Intel® Pentium® Processor N4200 and Celeron® Processors J3355, J3455 & N3350 for Internet of Things Platforms

Specification Update Addendum - Public

Revision 002

6.1.4.2 Package Diagrams

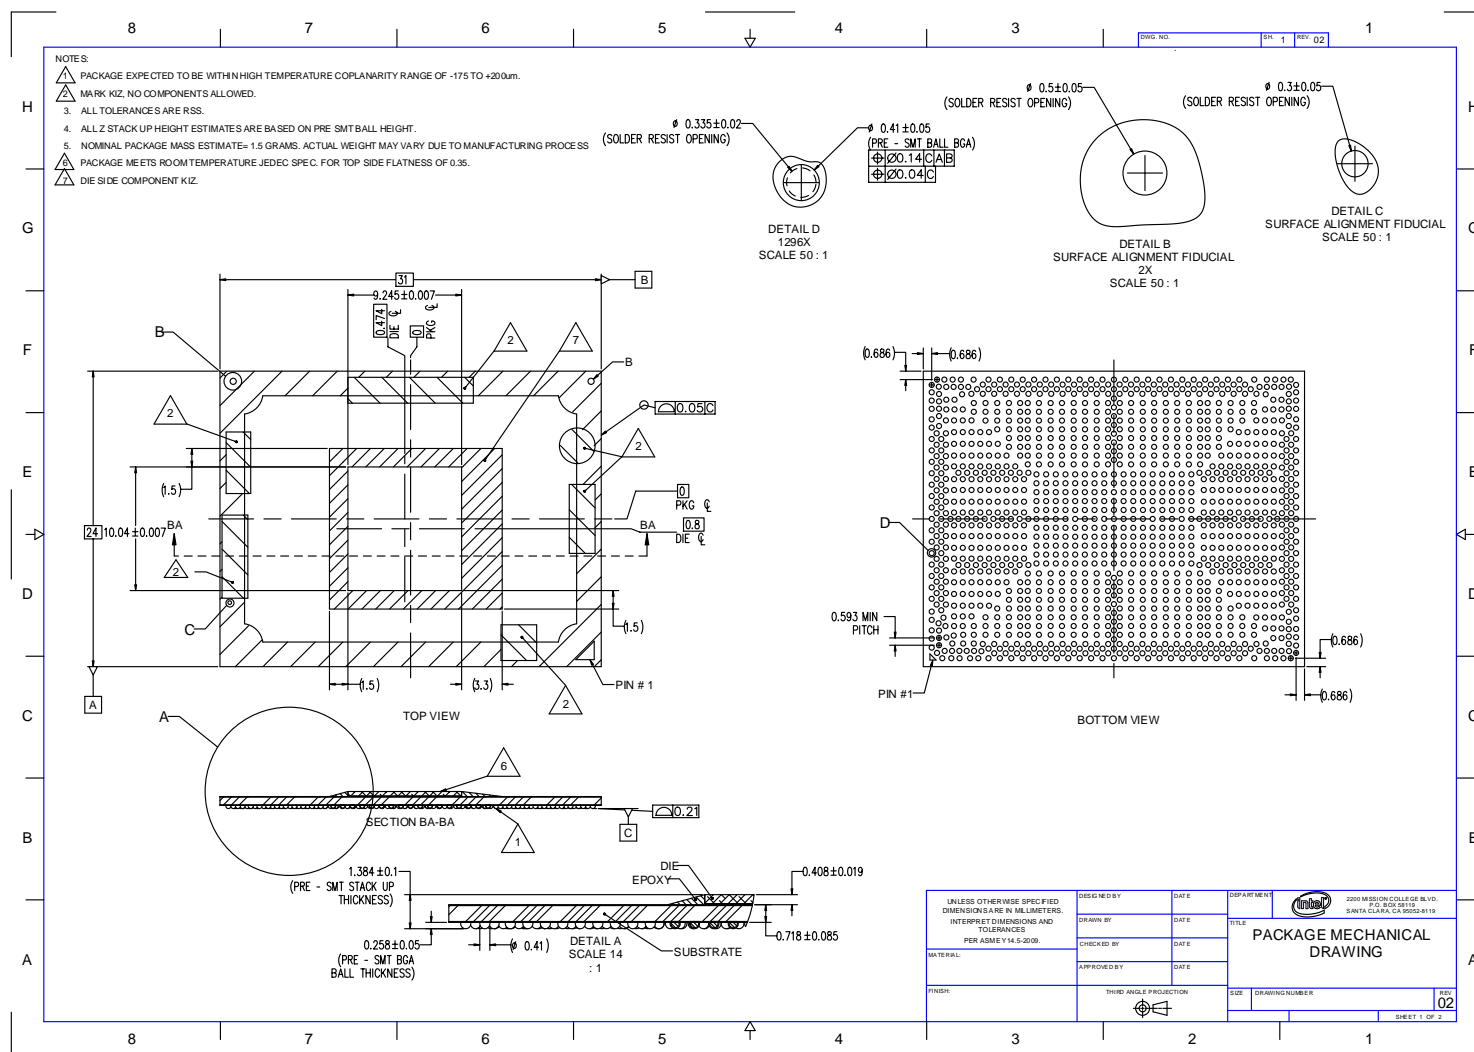
For the Intel® Pentium® processor N4200 and Intel® Celeron® processors J3355, J3455 & N3350, Figure 7-1 in EDS Volume 1 (Document number: 334817) is updated as described below:
